**PREVOST**

**WARRANTY BULLETIN**

**WB19-40**

| SUBJECT :   | <b>AWNING WINDOW MOTOR REPLACEMENT</b> |           |         |

FIGURE 1: COVER (4 TOP & 4 BOTTOM) AND RAIL STOP SCREWS

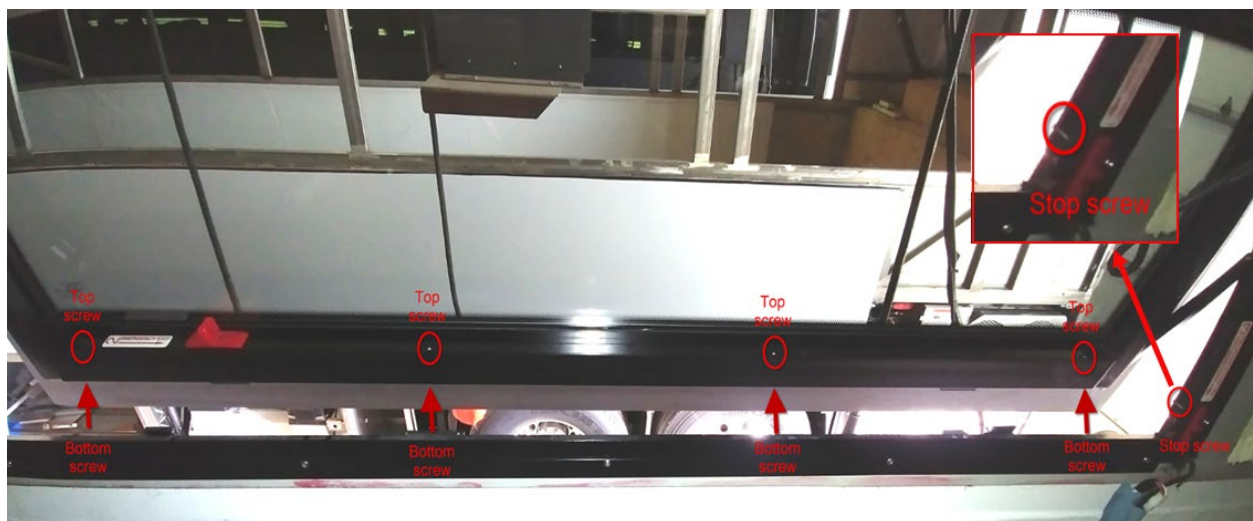
- Remove the bottom window cover to access the motor (four top screws & four bottom screws - Figure 1).
- Disconnect the motor (2 PIN connector – Figure 2).
- Remove the window arm stop screw located on the lower part of the vehicle window frame (arm rail on the fixed part of the window frame – Figure 1).
- Disengage the arm roller from the vehicle frame (rotate down to unhinge).
- Rotate the arm to access the set screw holding it to the motor shaft – Figure 3.
- Loosen the arm set screw & pull the arm off the motor shaft.
- Remove the two bottom screws securing the motor to the window frame – Figure 3.
- Remove the old motor.

- Position the new motor (with inline ceramic resistor) and secure to the frame using the previously removed bottom screws.
- Install the arm on the hex tip of the new motor.
- Secure the arm to the shaft (set screw).
- Rotate the arm and insert the roller in the vehicle frame rail (move up).
- Reinstall the arm stop screw at the bottom of the rail.
- Connect the new motor (make sure the resistor will clear frame and cover).
- Reinstall the window bottom cover (top & bottom screws).
- Reconnect the vehicle power supply & cycle (open/close) the window at least 5 times to confirm proper function.
